Project Name: Ginko Self Storage
 Description: Preliminary site plan and special land use approval
 Date on Agenda this packet pertains to: February 1, 2024

RE: Ginko Self Storage - Preliminary Site Plan Review- 4th Review

RE: Ginko Self-Storage
Preliminary Site Plan and Special Land Use – Review #4

The Fire Department has the following comments with regards to the 4th review of preliminary site plans for the project known as Ginko Self Storage.

ORIGINAL ISSUE DATE:
FEBRUARY 2, 2023
DRAWING TITLE
PRELIMINARY SITE PLAN

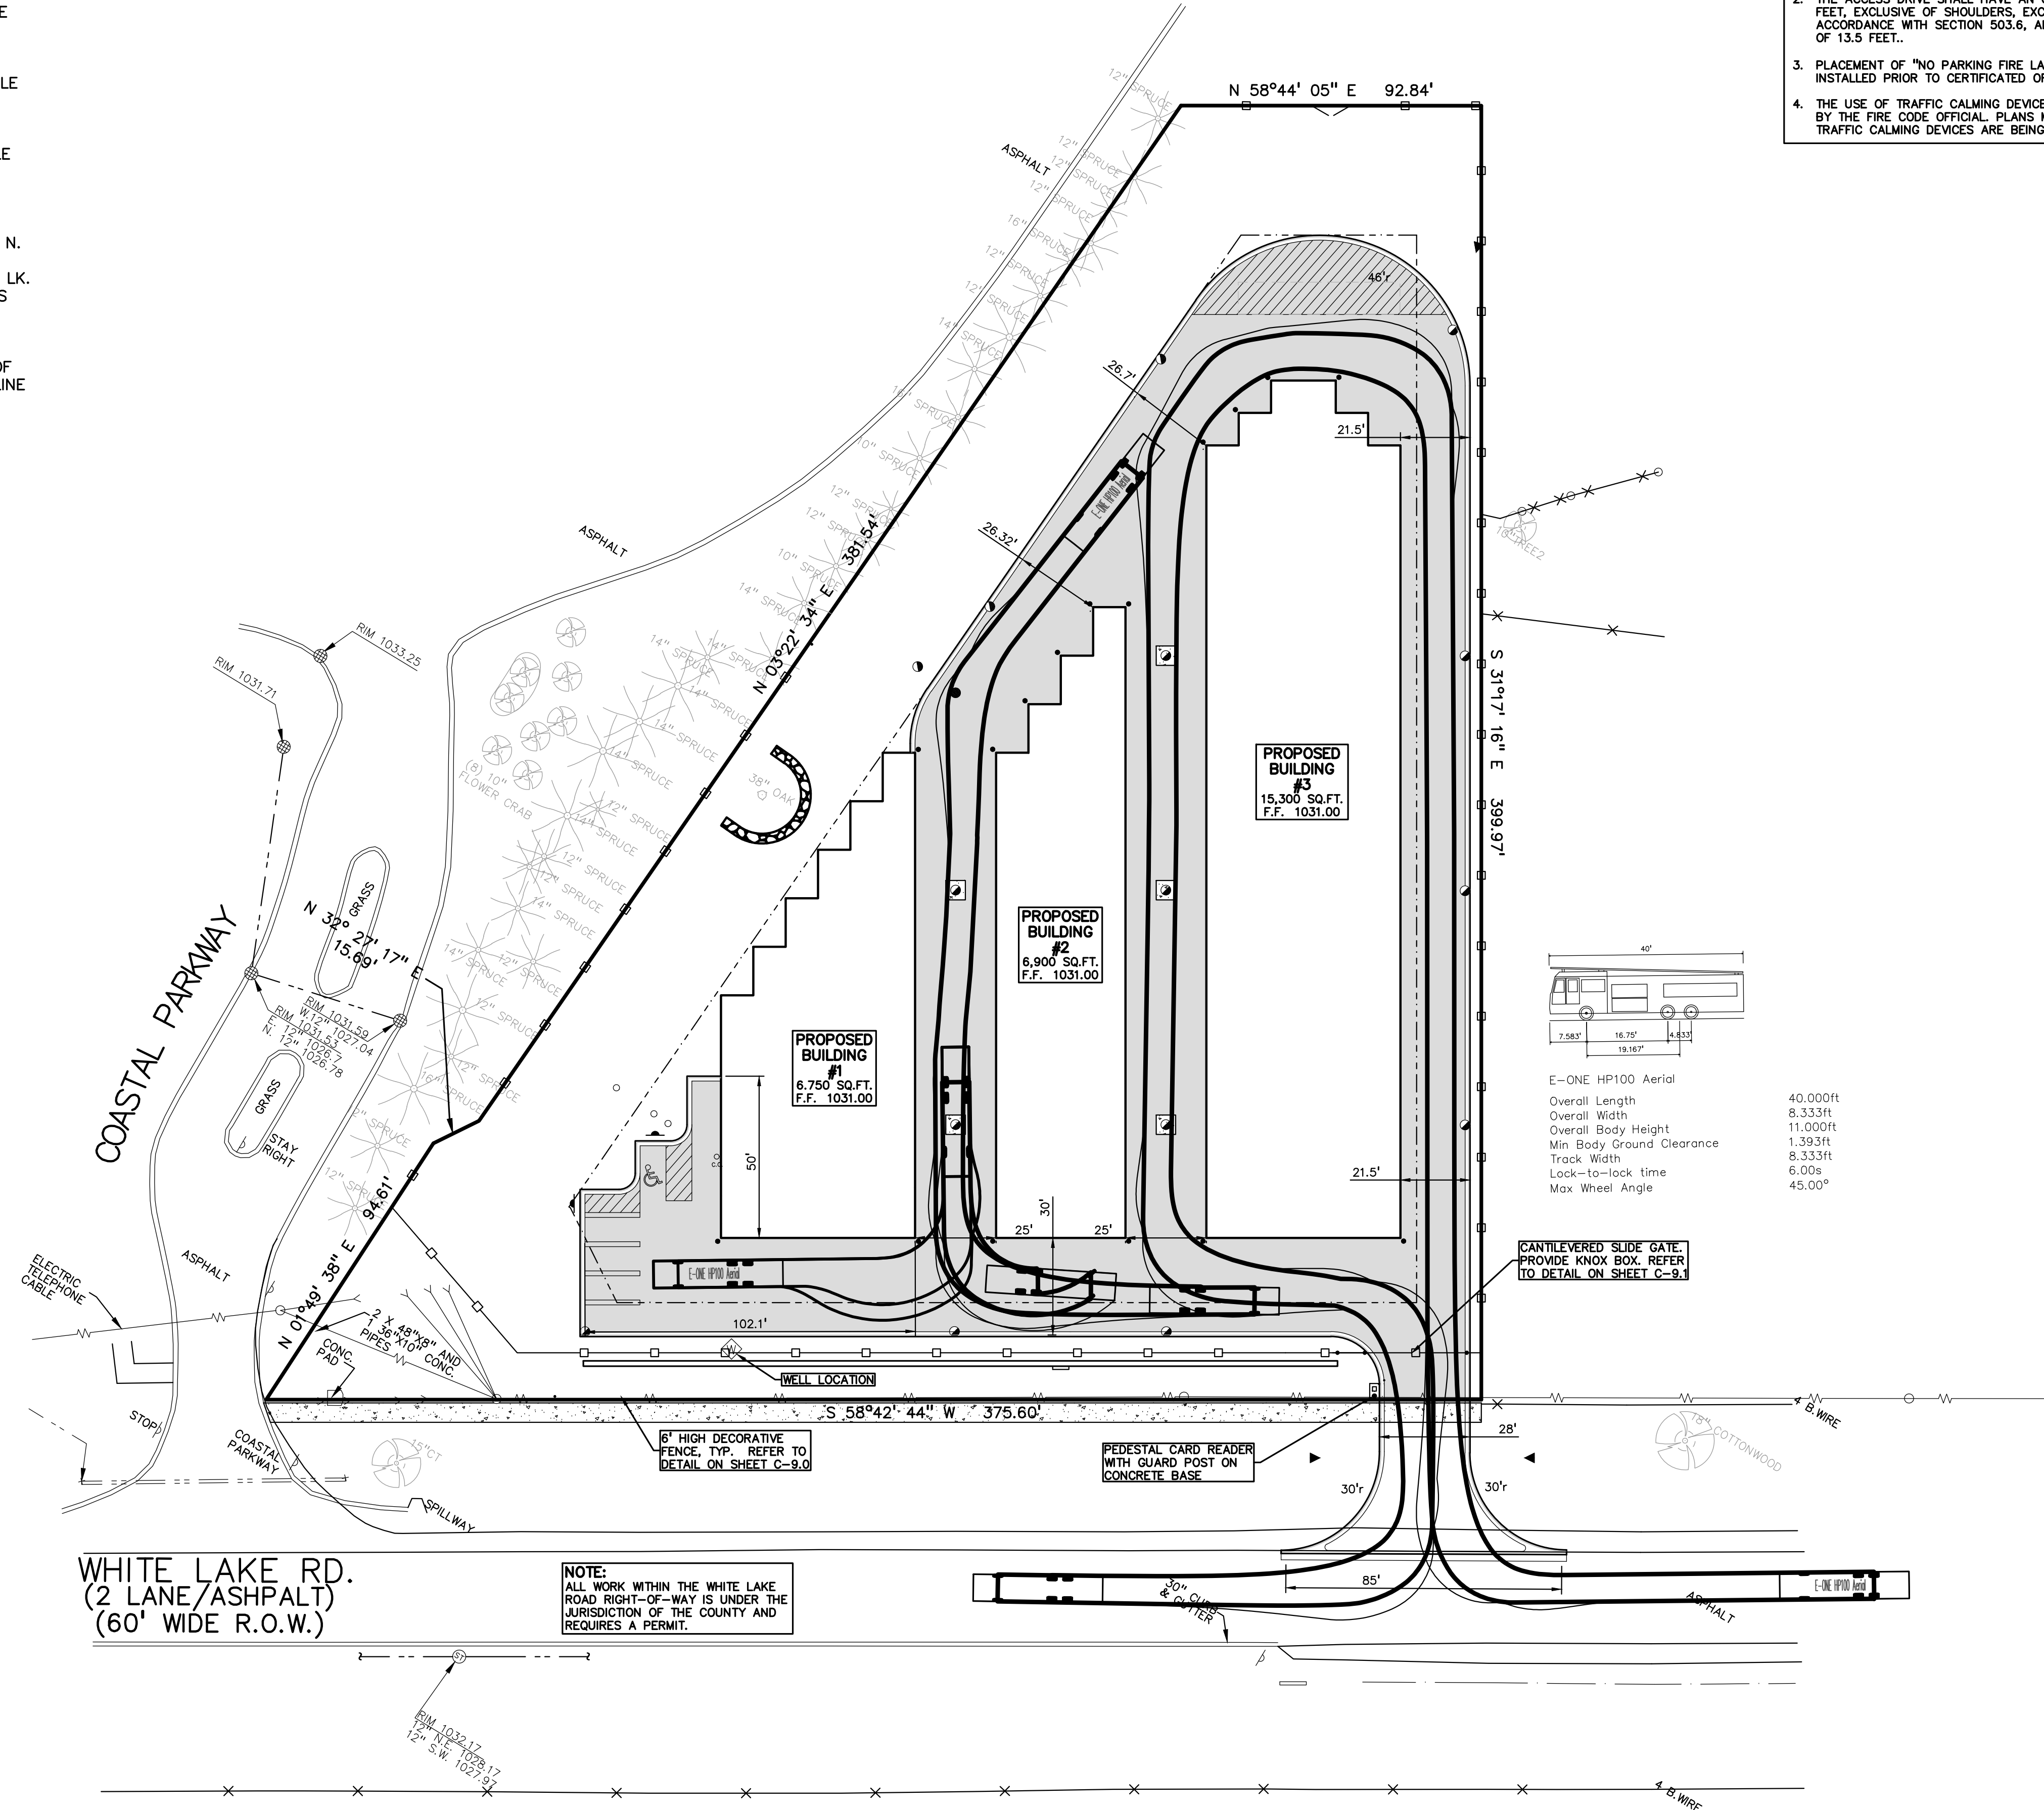
A 28-foot-wide (now 30-foot-wide) cantilevered slide gate is proposed at the driveway (Sheet C-3.1 still shows a 28-foot-wide gate – revise for consistency). (Comment addressed. Sheet C-3.0 shows the gate is 30-foot-wide; the 28-foot dimension noted on Sheet C-3.1 is the dimension of the access drive from back-of-curb to back-of-curb (25-foot-wide drive aisle provided between edges of the gutter pan). **Gated vehicular access is subject to review and approval by the Fire Department, and a permit is required from the Building Official.** (Comment remains as a notation. Gate details/specifications shall be provided at final site plan).

No dumpster is proposed. If a dumpster is proposed in the future, an amended site plan shall be submitted for administrative review to ensure the location and screening comply with the zoning ordinance standards. **A note reiterating the prior sentences shall be added to Sheet C-3.0. (Comment addressed. A note has been added to the plan).**

For self-storage, the zoning ordinance requires four spaces per 1,000 square feet of office plus one per employee working the largest shift. The parking calculations within the Site Data Table on Sheet C-3.0 indicates five parking spaces are required. Three parking spaces are proposed. **The site plan notes a variance to allow a reduction in parking is required. (Comment outstanding. A variance is required from the Zoning Board of Appeals). (Comment rescinded. The revised plan provides the required number of parking spaces). It is unclear how vehicles would maneuver out of the proposed parking spaces – clarify intended circulation for vehicles exiting proposed parking spaces. (Comment partially addressed. A paved area adjacent to the parking spaces has been provided. A ‘No Parking’ sign and hatched pavement striping shall be provided to deter parking in this area. (Comment addressed. Sheet C-3.0 shows the aforementioned items). A ‘No parking’ sign detail and hatched pavement striping detail shall be provided). (Comment outstanding. A ‘No Parking’ sign detail has not been provided). (Comment addressed. A ‘No Parking’ sign detail has been provided on Sheet C-9.0).**

- **24-hour self-storage shall be prohibited; the self-storage facility shall be closed daily between 10:00 p.m. and 6:00 a.m. (Comment remains as a notation. General Note 6 has been added to Sheet C-3.0 reiterating the previous statement).**

DRAWING TITLE
NOTES AND DETAILS

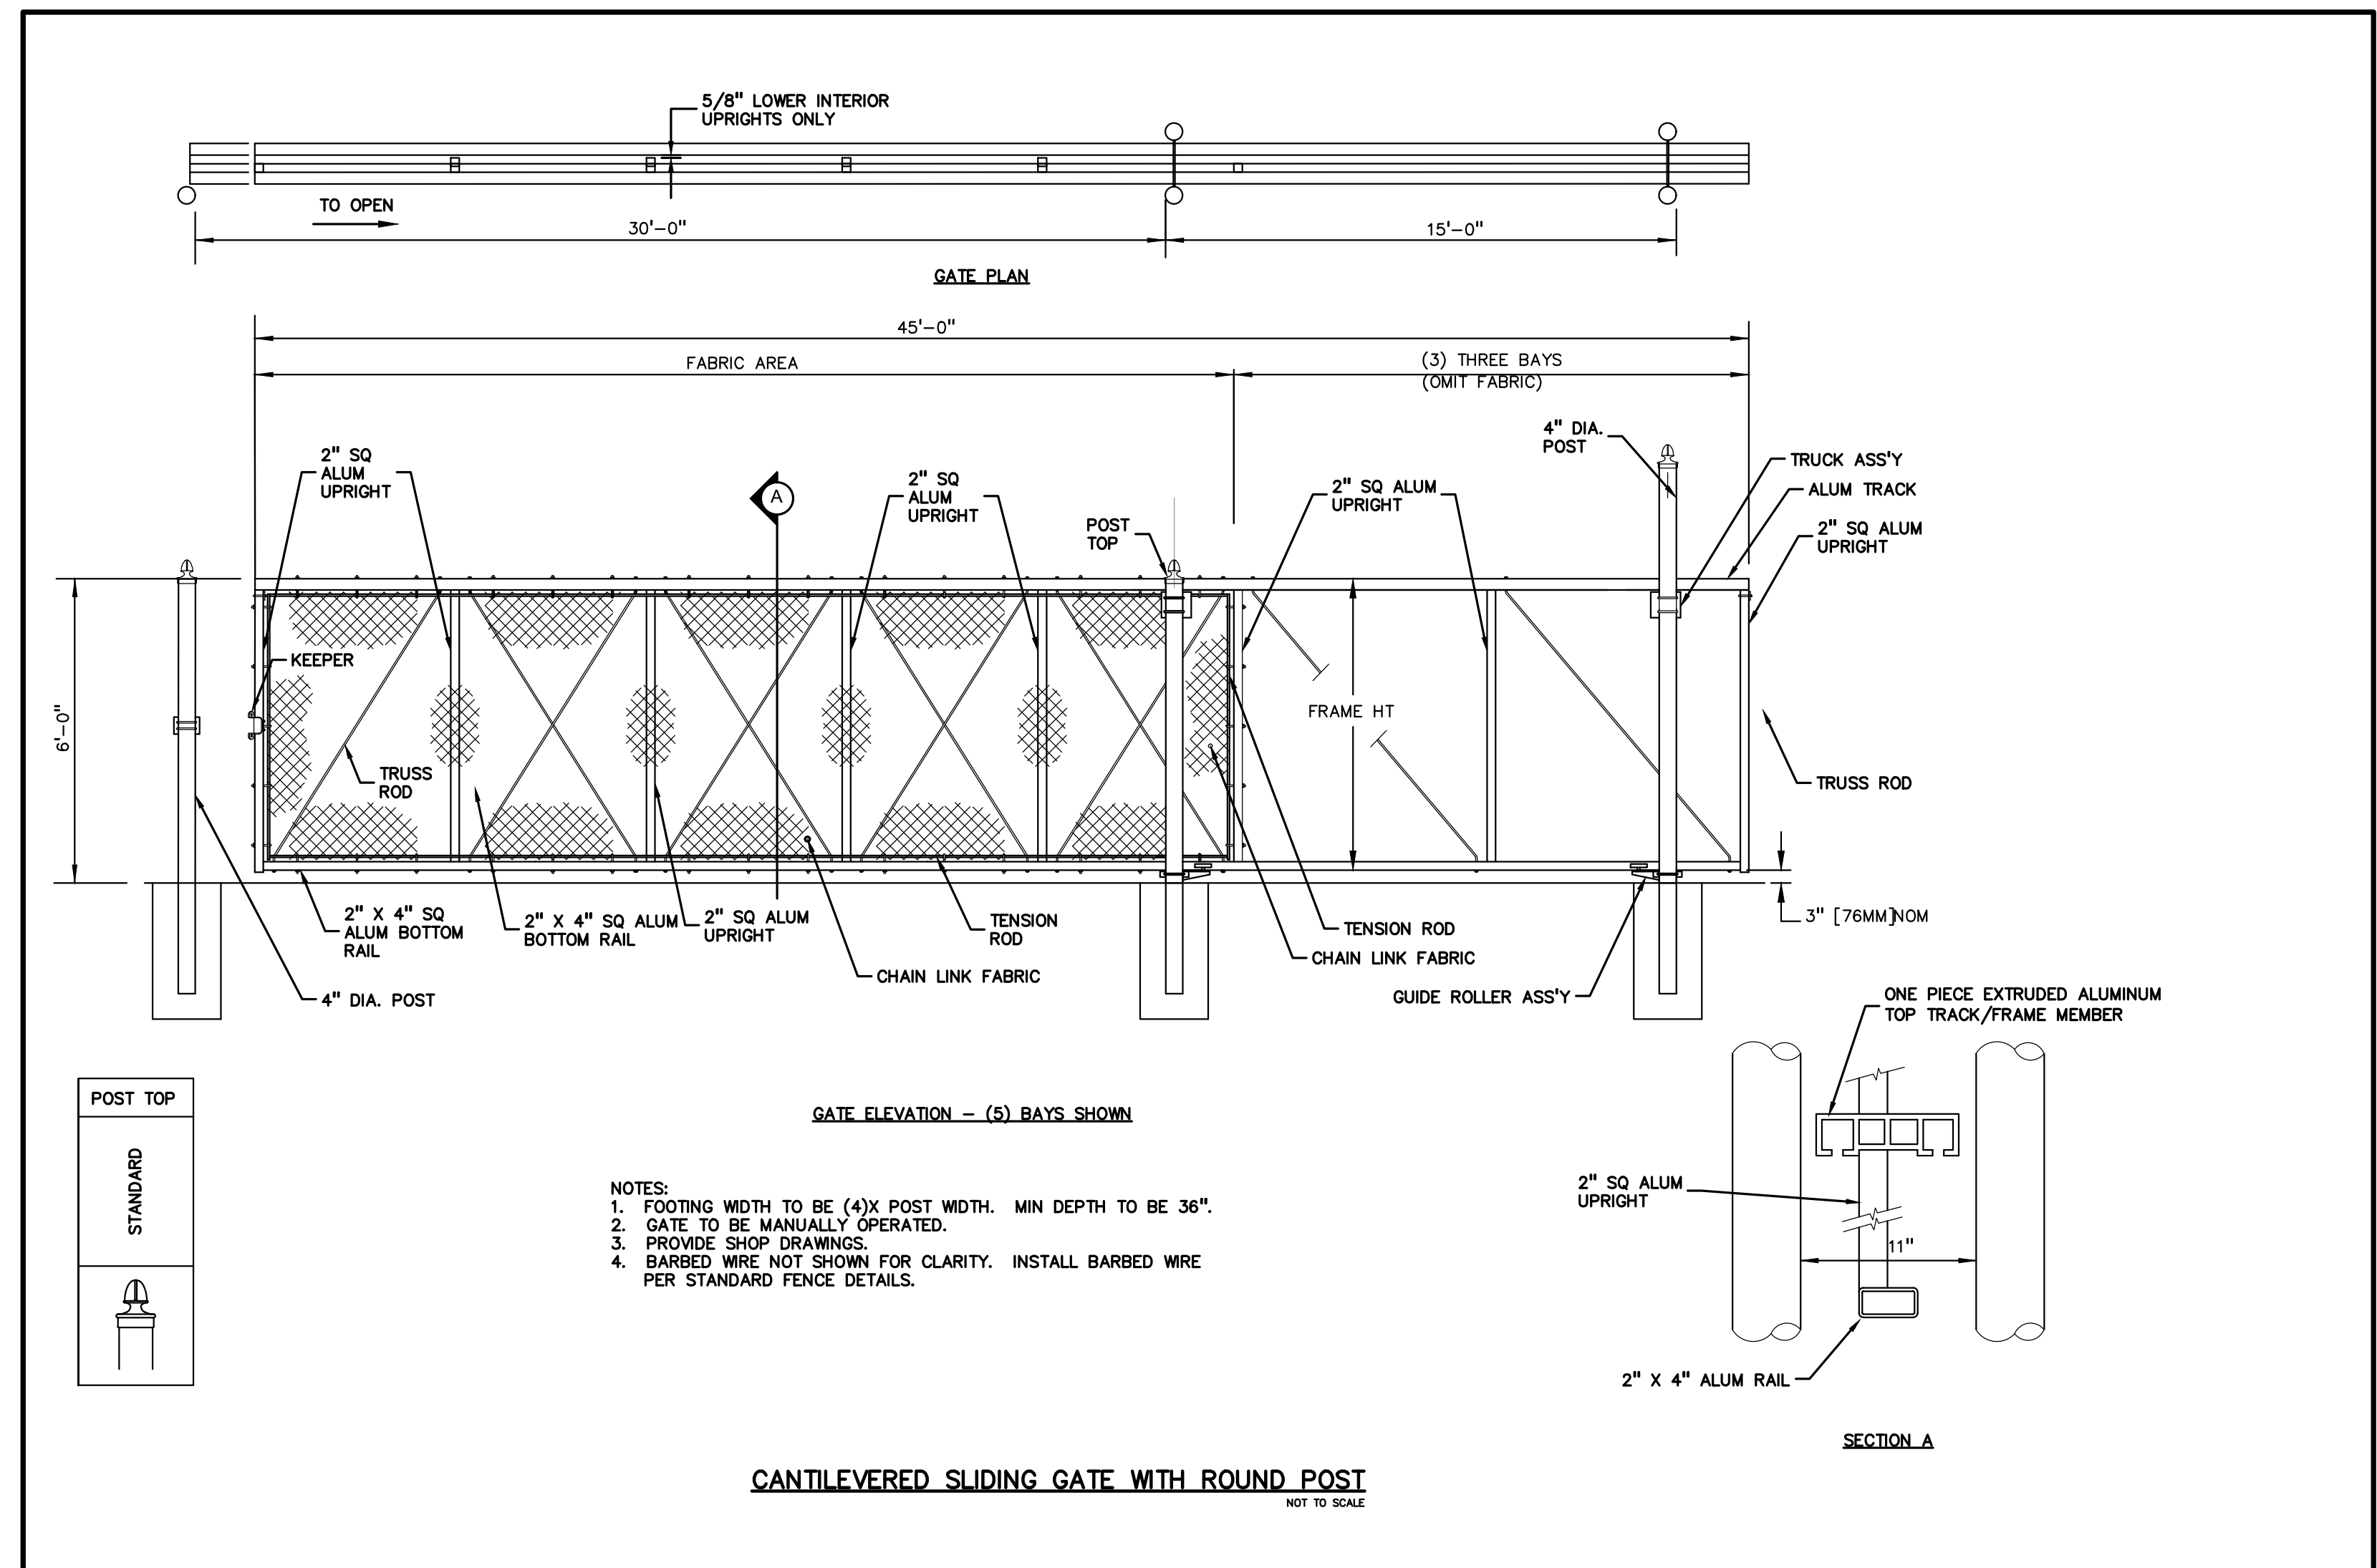
- **Cyclone fencing should not be permissible and shall be removed from the plan. Remove the chain link fence detail and the chain link access gate detail from Sheet C-9.0. A different fencing type may be proposed for consideration.** (Comments addressed. A decorative fence (non-obscuring) has been proposed. At final site plan, the Planning Commission shall determine if non-obscuring fencing is acceptable. Also, the Applicant shall clarify why decorative fencing has not been proposed around the entire property (no fencing at northwest portion of the property).

The zoning ordinance requires each individual parking space (with the exception of barrier free spaces) be delineated by dual stripes, two feet apart centered on the dividing lines and painted white. Revise the site plan to show the box pattern, and provide a parking stall striping detail. If the required striping is not provided, a variance must be requested from the Zoning Board of Appeals. (Comment partially addressed. The site plan has been revised to show the box pattern with a note regarding dual striping. However, a parking stall striping detail has not been provided). (Comment addressed. A double striping detail has been provided on Sheet C-9.0). A “Van Accessible” sign detail for the barrier-free parking shall also be provided (the sign legend on Sheet C-3.0 states refer to detail sheet for sign details, but no sign details are provided on Sheet C-9.0). (Comment addressed. Sign details have been provided on Sheet C-9.0).
